Re: Feedback on SSD Application: Hawkesbury Centre of Excellence in Agricultural

Education

The photograph below shows the current state of the Hobartville/Richmond section of Londonderry Road.

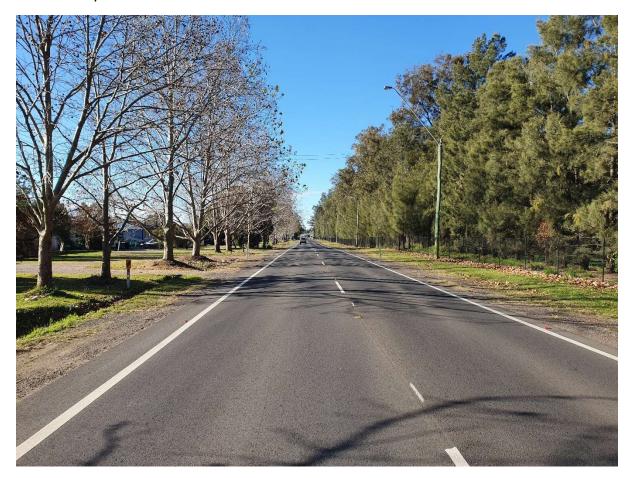
- The Hobartville / Richmond section of Londonderry Road has drainage issues and often localised flooding on either side of the road following heavy rain.

The Green highlighted area on the above map along Londonderry Road, is where I would argue a footpath, kerb and gutter and drainage should be installed.

- Installation of kerb and gutter.
- Installation of footpath.
- Installation of drainage.
